UNITED STATES PATENT AND TRADEMARK OFFICE

APPLICATION NO.	FILING DATE	FIRST NAMED INVENTOR	ATTORNEY DOCKET NO.	CONFIRMATION NO.
09/992,786	11/13/2001	John Barnes	220772008900	5825

Office Action Summary

DETAILED ACTION

FIGURE 1 from GROVE, JR. et al. (US 3,073,685)

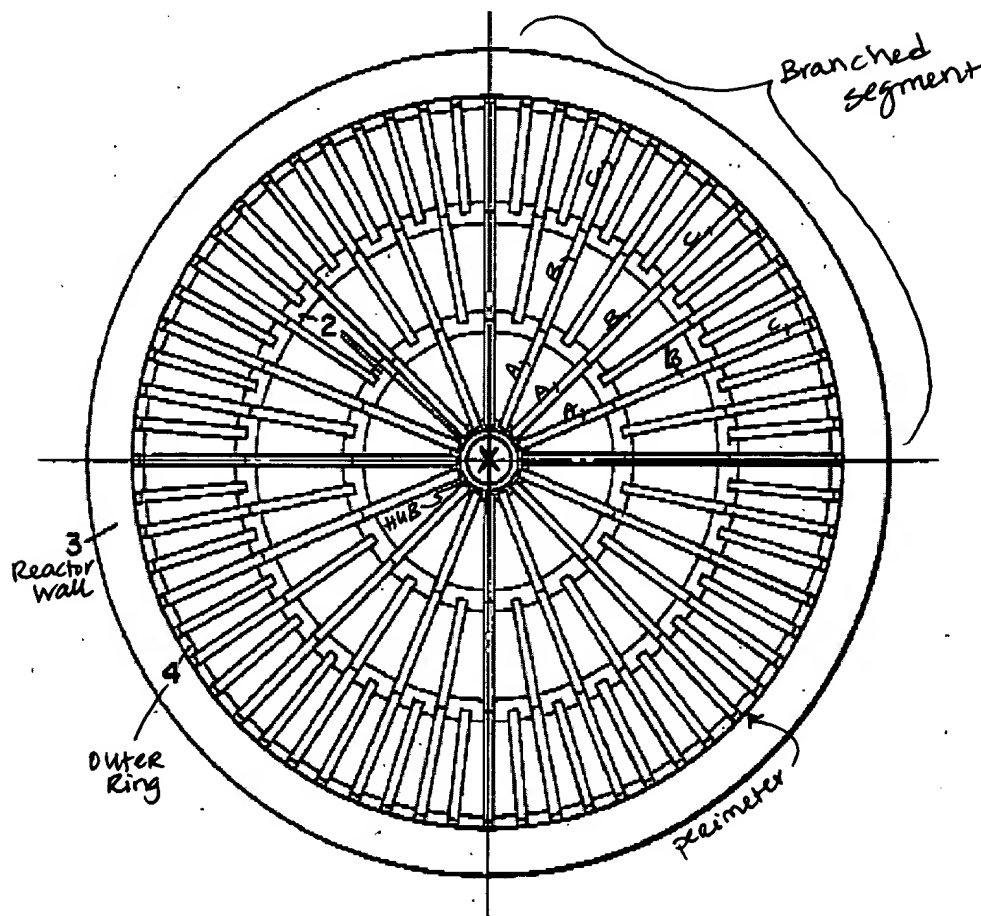
Regarding claims 1, 4, 7, 16 and 17, Grove, Jr. et al. discloses a structure (i.e., the catalyst support structure shown in FIG. 1, relabeled by the Examiner, below) comprising:

a plurality of struts (i.e., straight support rods **1**, labeled as rods **A**, **B** and **C**); said struts **A,B,C** being configured in at least two branched segments radially arranged about the center (i.e., at hub **X**, comprising castable refractory **2**);

each branched segment comprising a primary strut **A** with a proximal end proximal to the center **X** and a distal end extending towards the perimeter (i.e., towards the reactor wall **3**);

each branched segment comprising a secondary strut **B** with a proximal end that contacts the primary strut **A** and a distal end that extends toward the perimeter (i.e., towards the circular reactor wall **3**); and

each branched segment comprising additional secondary struts **C** having a proximal end in contact with the previous strut **B** toward the center **X** and a distal end extending toward the perimeter (i.e., towards the reactor wall **3**), said additional secondary struts **C** alternating in a branched fashion in a direction from the center toward the perimeter (see Fig. 1).

Regarding claim 2, the distance between alternate consecutive secondary struts **B,C** in a branched segment is substantially constant (see FIG. 1).

Regarding claim 5, alternate secondary struts **B,C** are substantially parallel to each other.

Regarding claims 29-32, 42 and 43, the support structure comprises an outer ring (i.e., a fire brick ledge **4**; FIG. 1) encompassing the branched segments, the outer ring including a plurality of peaks and troughs (i.e., troughs defined by slots **3**, **4**, **5**; FIG. 4), wherein the distal end of some of the struts (i.e., struts **C**) are coupled to the outer ring at the troughs (i.e., within the slots), thereby defining a slip joint.

Regarding claims 33, 34, 44 and 45, the distal end of at least one strut **A,B,C** includes a flange (i.e., as defined by the end of the strut which overlaps the refractory rings **2** and **4**; FIG. 1); the structure including an outer ring **4** (FIG. 1) having an expansion slot (e.g., slots **4**; FIG. 4) wherein the flange (i.e., the end of the strut) is received within the expansion slot **4**.

FIGURE 8 from BRUNNER et al. (US 5,725,810)

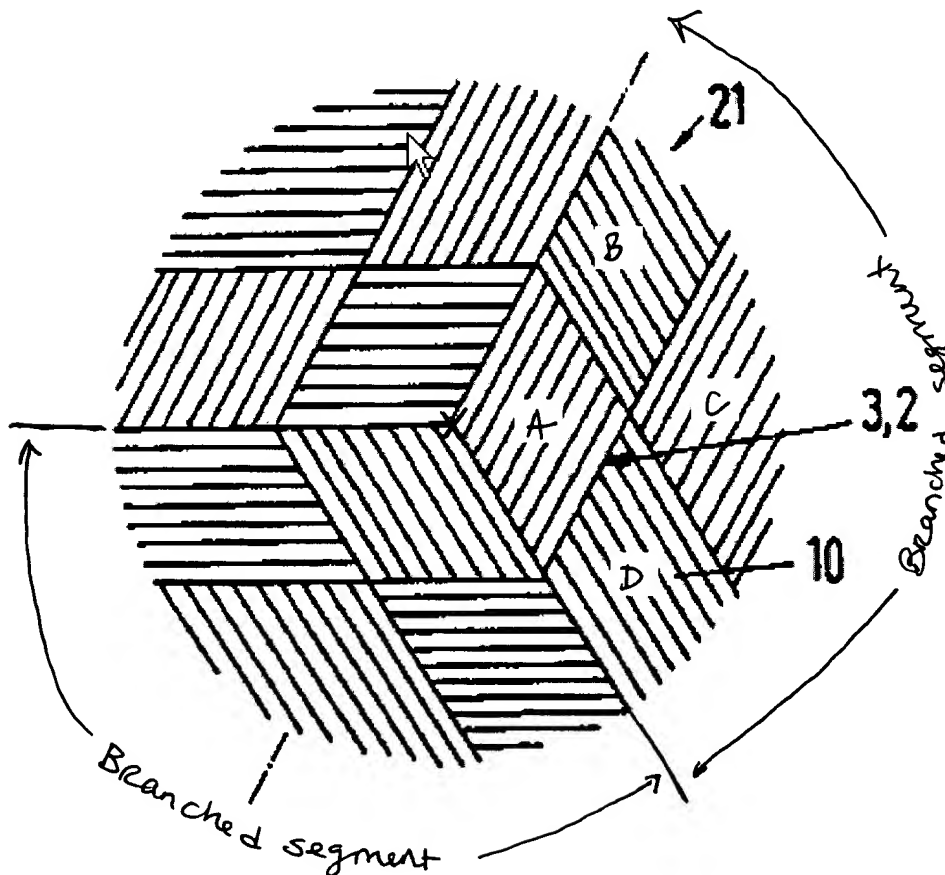
Regarding claims 1, 4 and 16, Brunner et al. (FIG. 8, 9a; FIG. 8 is relabeled by the Examiner, below) discloses a structure comprising:

a plurality of struts (i.e., packing elements 2, formed by sheets 1) configured in at least two branched segments (i.e., three shown in FIG. 8) radially arranged about the center X;

each branched segment comprising a primary strut (i.e., a sheet 1 within section A) with a proximal end proximal to the center X and a distal end extending toward the perimeter;

each branched segment comprising a secondary strut (i.e., a sheet 1 within section **B**) with a proximal end contacting the primary strut (i.e., the sheet 1 within section **A**) and a distal end extending toward the perimeter; and

each branched segment comprising additional secondary struts (i.e., sheets 1 within sections **C**, **D**) with proximal and distal ends, the additional secondary struts alternating in a branched fashion in a direction from the center **X** toward the perimeter, wherein the proximal end of each additional secondary strut (e.g., sheet 1 within section **C**) contacts the previous strut (i.e., sheet 1 within section **B**) toward the center **X** and the distal end of each additional secondary strut (i.e., sheet 1 within section **C**) extends toward the perimeter.

Regarding claim 2, the distance between alternate consecutive secondary struts 1 is substantially constant (see FIG. 8).

Regarding claim 3, at least one strut 1 of one branched segment is parallel to at least one strut 1 of another branched segment (see FIG. 8).

Regarding claim 5, alternate secondary struts 1 are substantially parallel to one another (see FIG. 8).

Regarding claim 9, each consecutive strut 1 is connected to the previous strut 1 at a variable distance from the proximal end of the previous strut 1 (see FIG. 8).
